WORKSHOP AGENDA

Planning Commission
June 16, 2026 @ 5:30 PM
For the June 30, 2026 Regular Meeting @ 6:00 PM

Planning Commission Report
Meeting: June 16, 2026

Item #: 3. **Site Plan - 1370 Heil Quaker Boulevard - Proposed Truck Parking on 2.51 Acres. Property located at 1370 Heil Quaker Blvd. (Tax Map 17, Parcel 28.01). ID (Interchange District) Zoning District. Property owned by Harsimranjeet Kaur. Requested by Huddleston Steele, Inc.**

SHEET NUMBER:
C-4.0

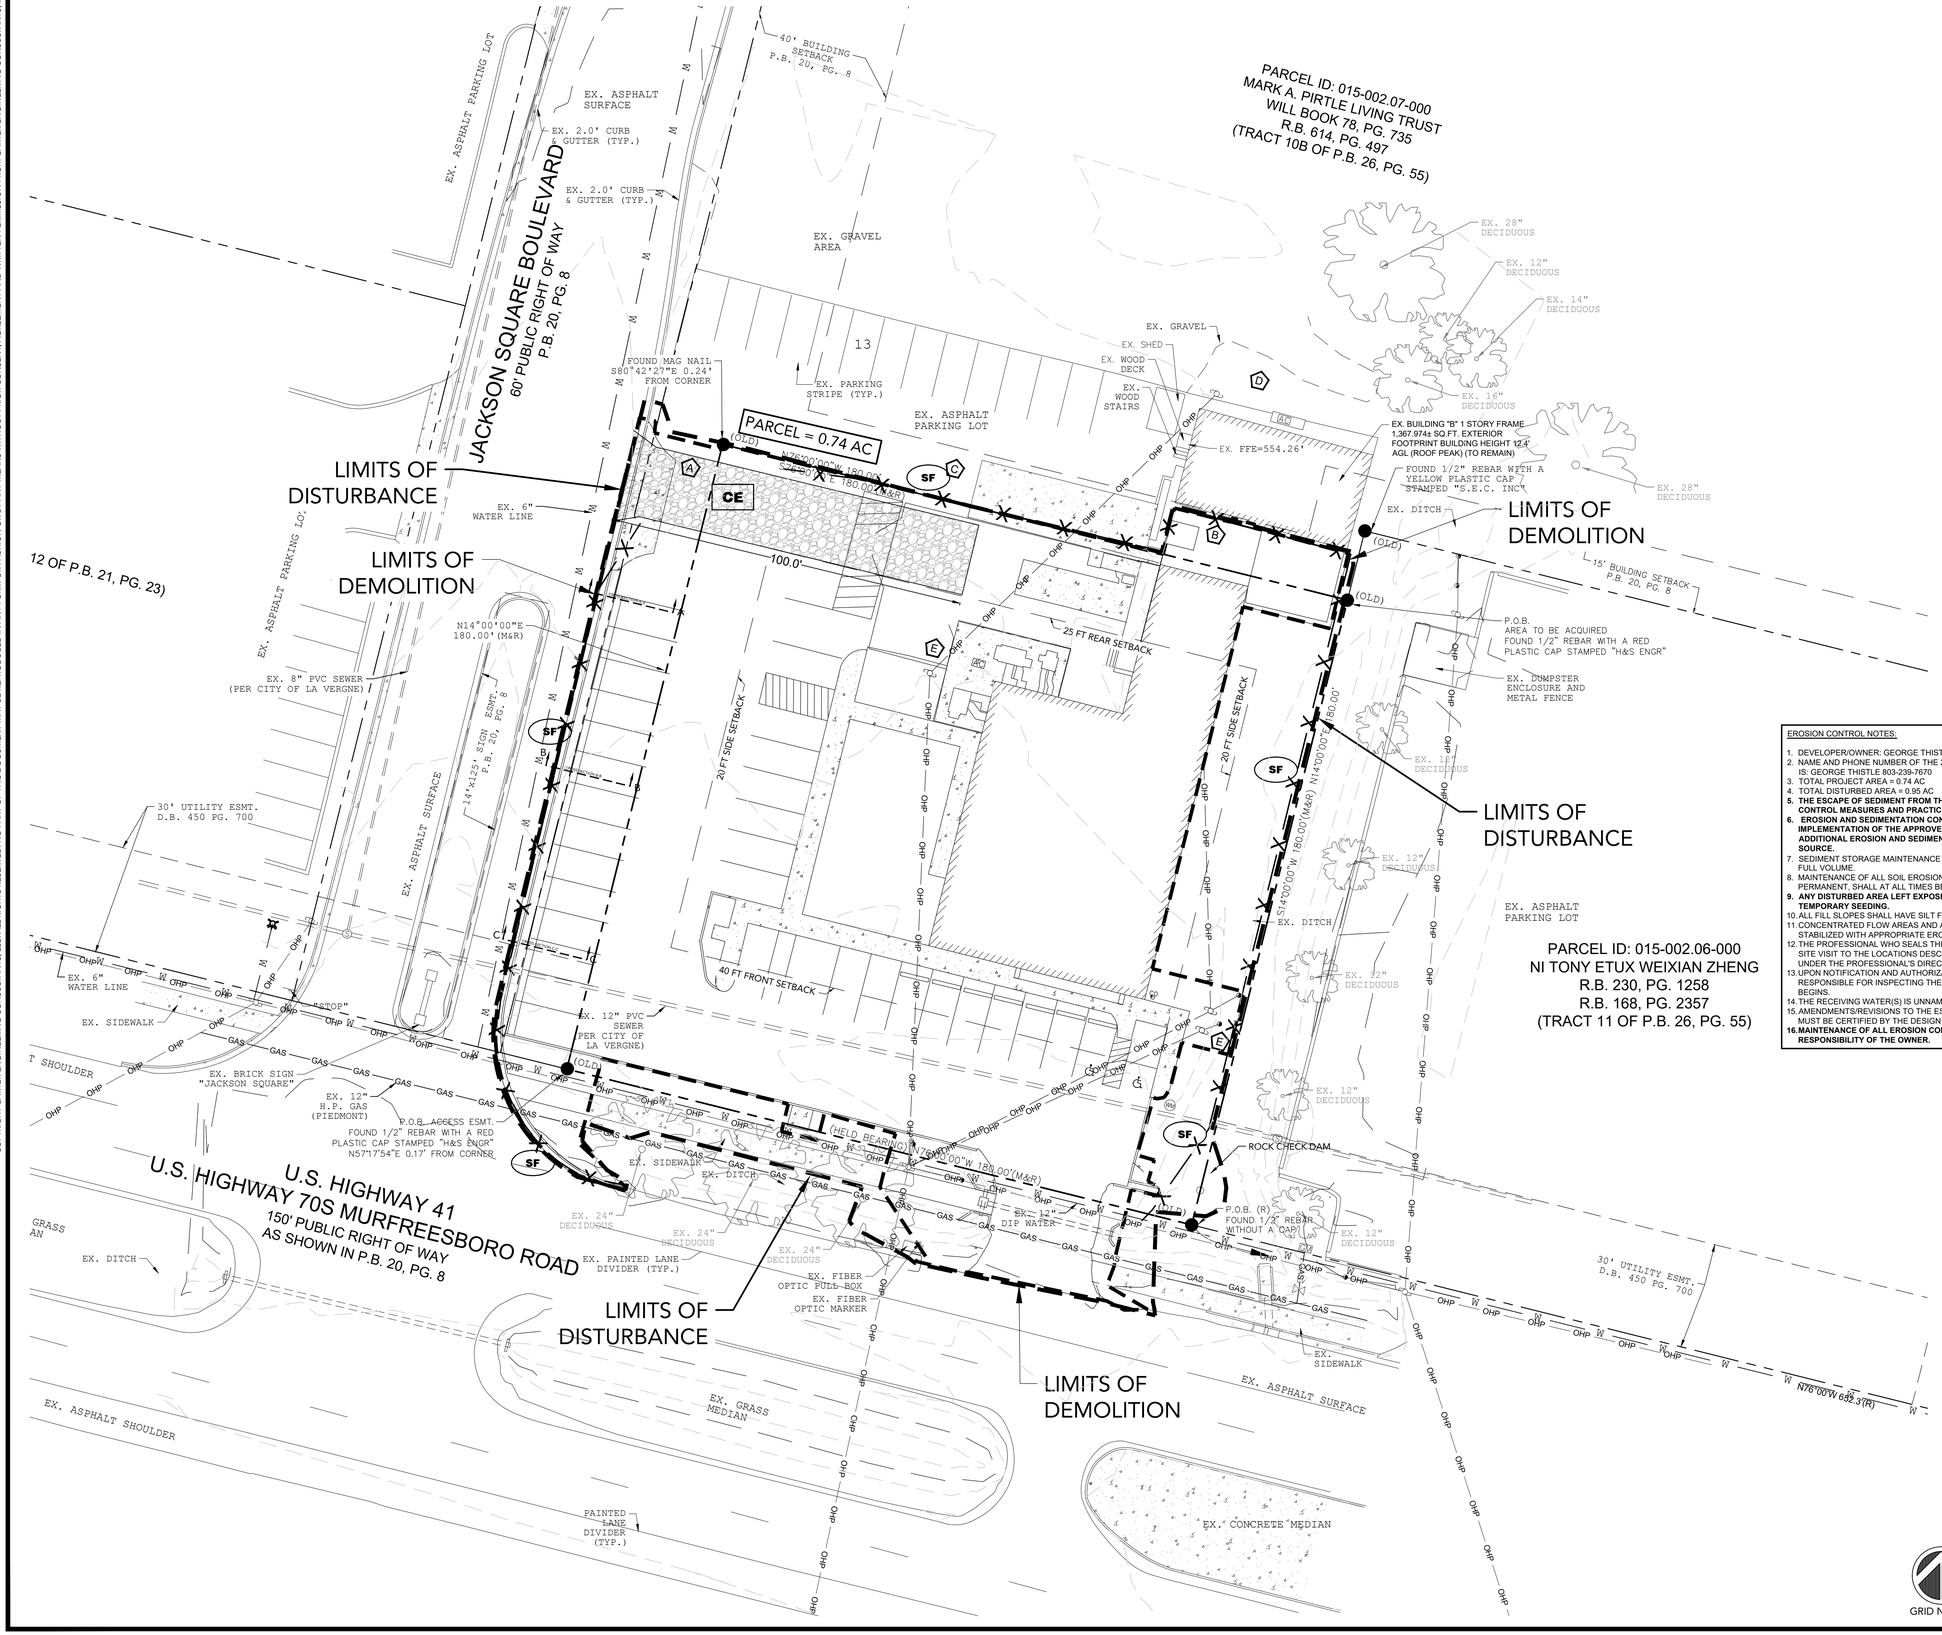
7. (Sheet C-4.0) Provide calculations proving that the proposed 12" PVC drain pipe under the public sidewalk will be sufficient to pass the 25-year/24-hour storm without overtopping the walk.

8. Sheet C-4.0)) Provide calculations proving that the proposed 15" RCP drain pipe under the drive from Murfreesboro Road will be sufficient to pass the 25-year/24-hour storm. This is in addition to any TDOT requirements.

Date: APRIL 06, 2026
Scale:
Sheet: C0.11 OF
Project No. 2018-15 | Prepared By: MF

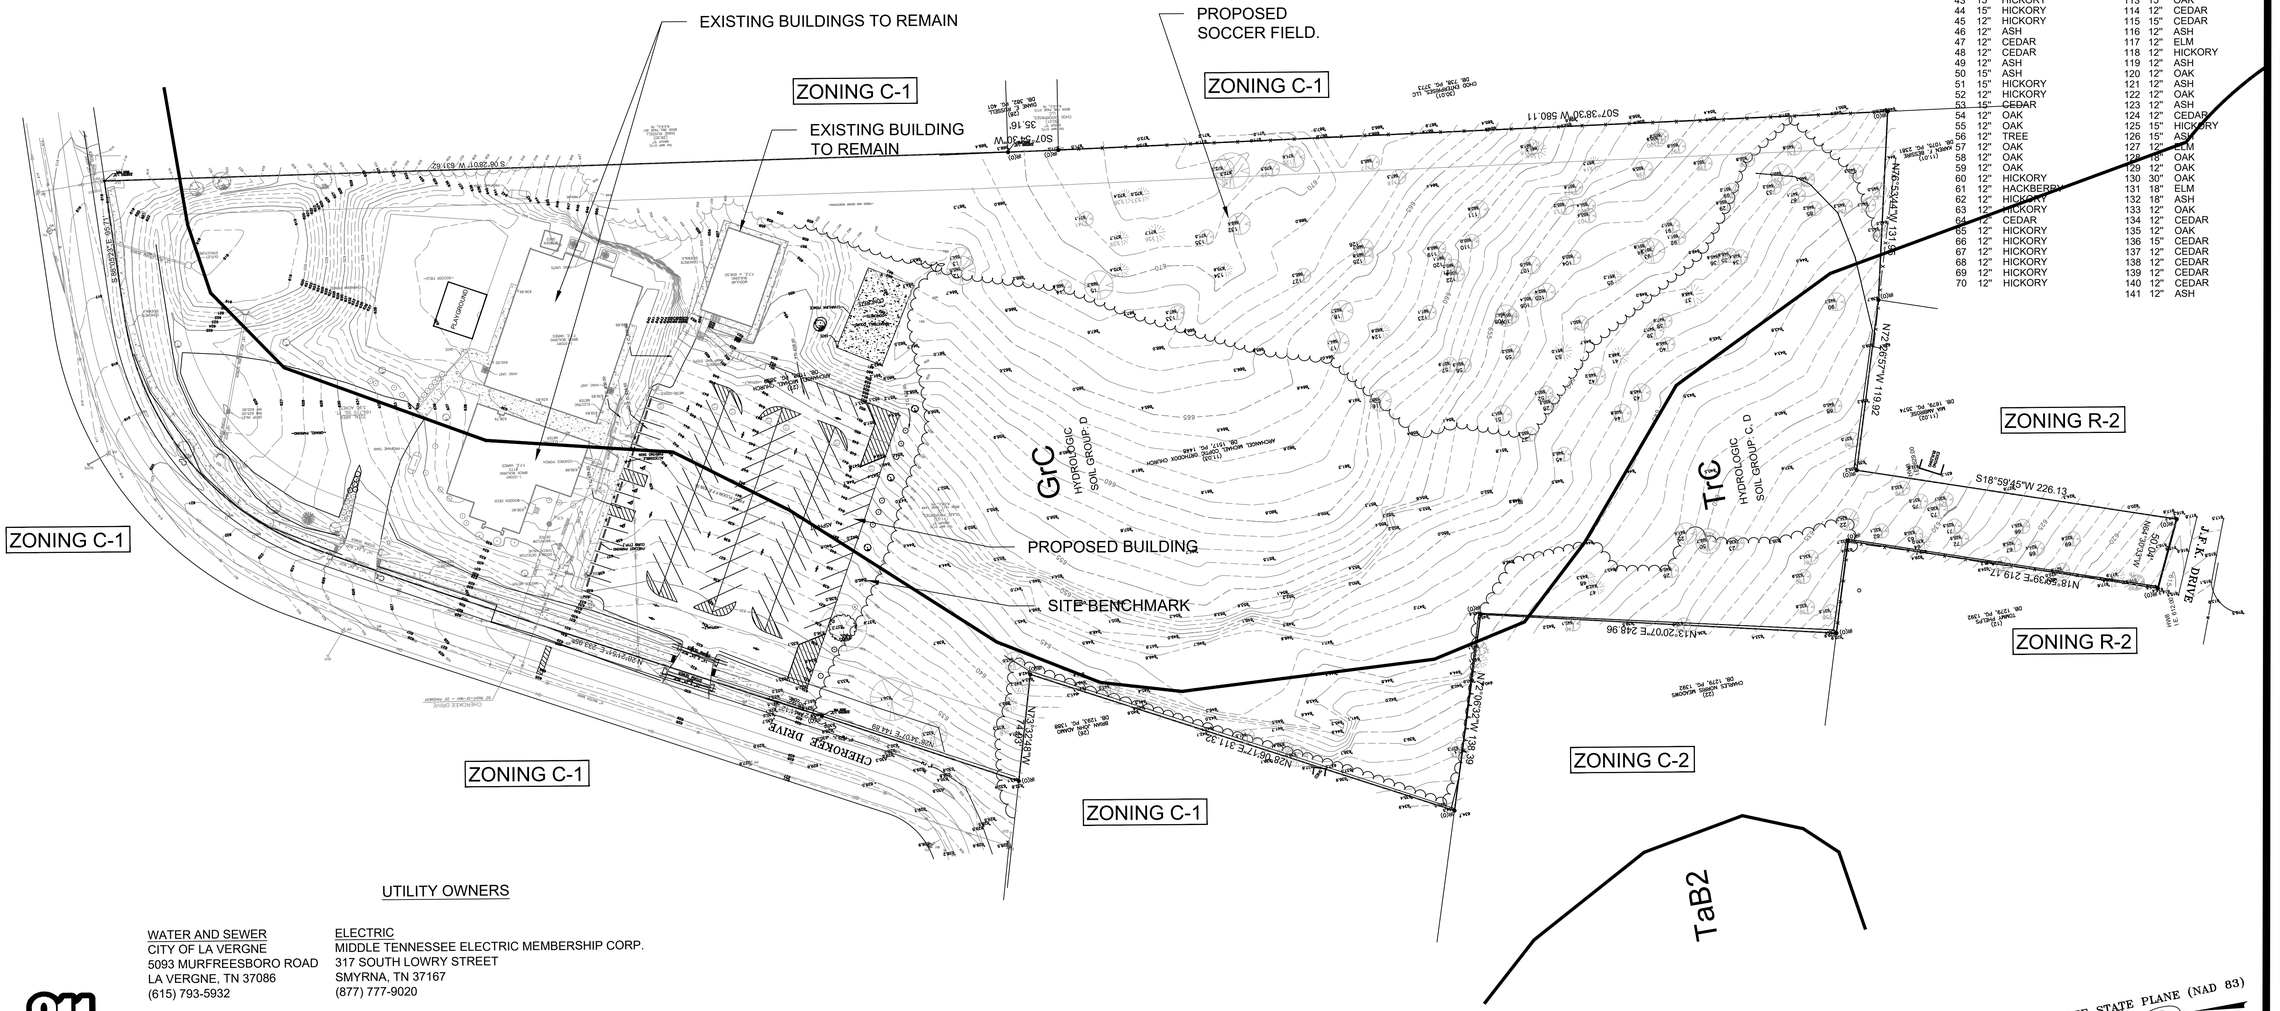
3. On LTMP, include a cost estimate for the maintenance of their structures.
4. (Sheet C0.11) Add curve table for boundary so that the sheet shows the entire boundary with all calls.

1. Sht C0.11, Boundary and Topographic Survey, shall have a survey datum statement providing the date and horizontal and vertical control. A signature block of the surveyor is also required.

Date: APRIL 06, 2026
Scale:
Sheet: C1.0 OF
Project No. 2018-15
Prepared By: MF

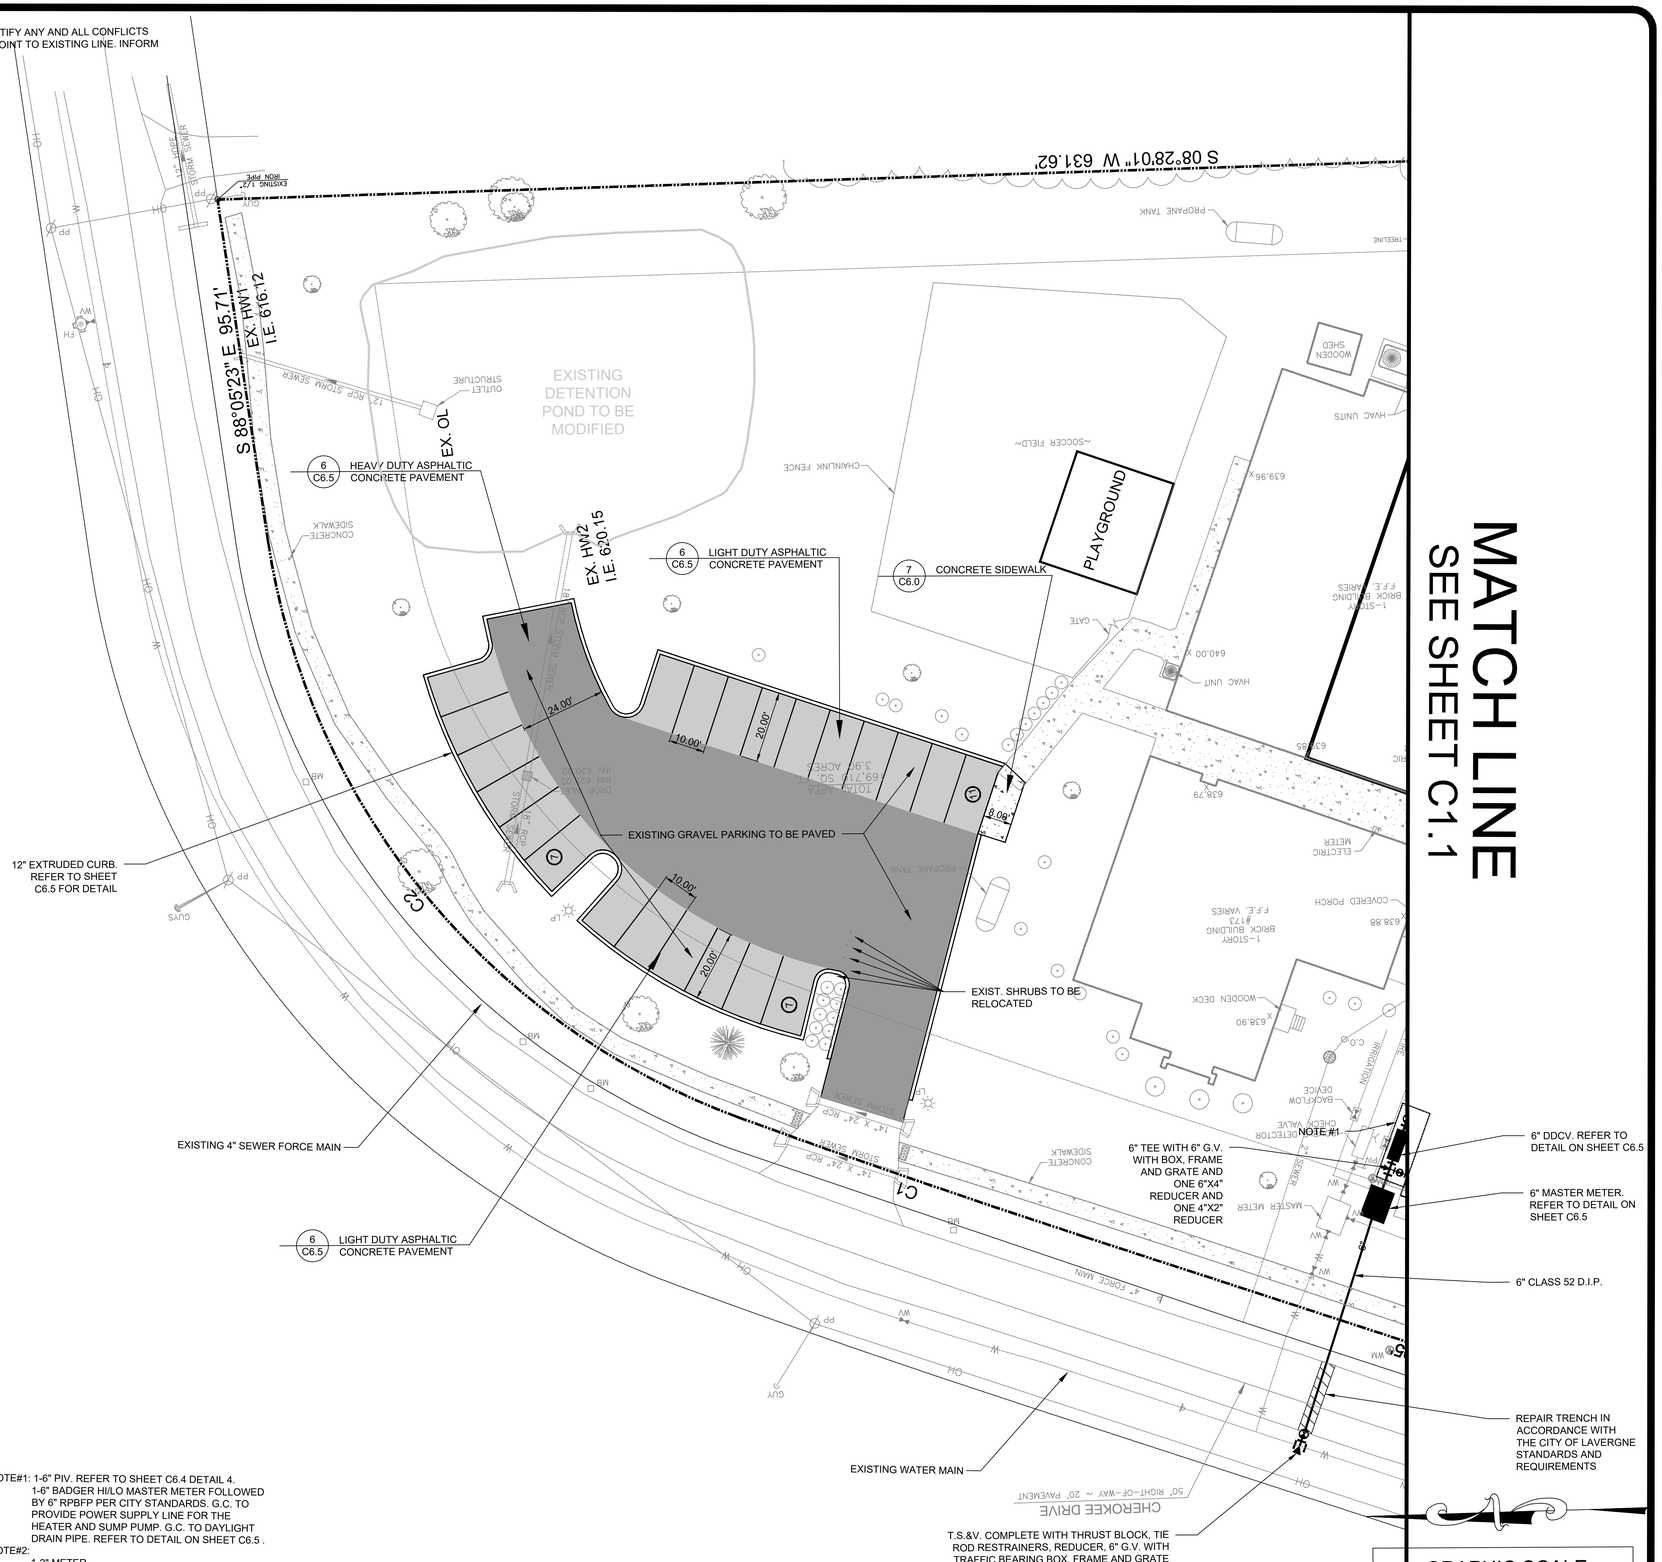
2. Sht C1.0 – Indicate size of existing waterline in Cherokee Dr. It is 6 inch.
3. If there is only one property being served, the property may have one water meter. The county map shows one property173 Cherokee Dr. Engineer shall utilize existing water meters for this new Site Plan design. If existing water meters are inadequate, new meters of appropriate size shall be installed.

6. Sht C1.0 - FH is served off piping downstream of the BFP assembly.
7. Sht C1.0 – Detail for Sewer Connection at Existing Line – refers to “MWS standard and requirements.” This was copy paste from another project and should be removed. La Vergne installed pressure connection boxes per City Std Dtl 19.0.
